Heritage On Main

Medway, Massachusetts

DESIGN REVIEW COMMITTEE PRESENTATION
AUGUST 3, 2026

Areas of Concern

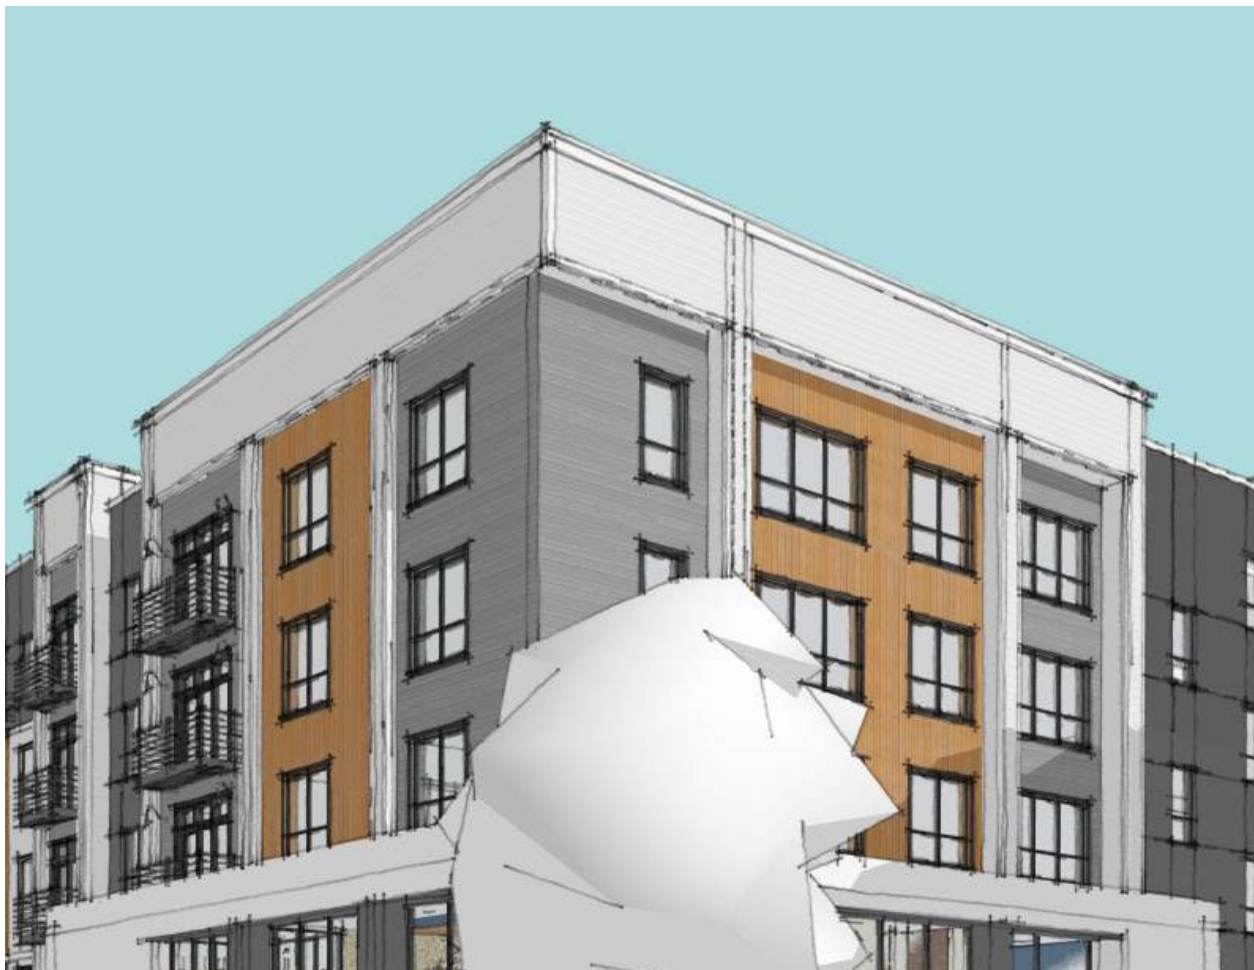
Comments encouraged an architectural language that utilizes more New England Village themes: gables, mansards and dormers.

Previous Multi-family facade's verticality created too much of a harsh 'urban edge' along Maint Street. Comments encouraged architectural moves to soften the facade's perception from ground level, reduce the appearance of it's overall height, create perception of the fourth floor being steppd back.

Previous comments expressed concern that projecting balconies on main street could result in undesirable aesthetics and views of resident belongings.
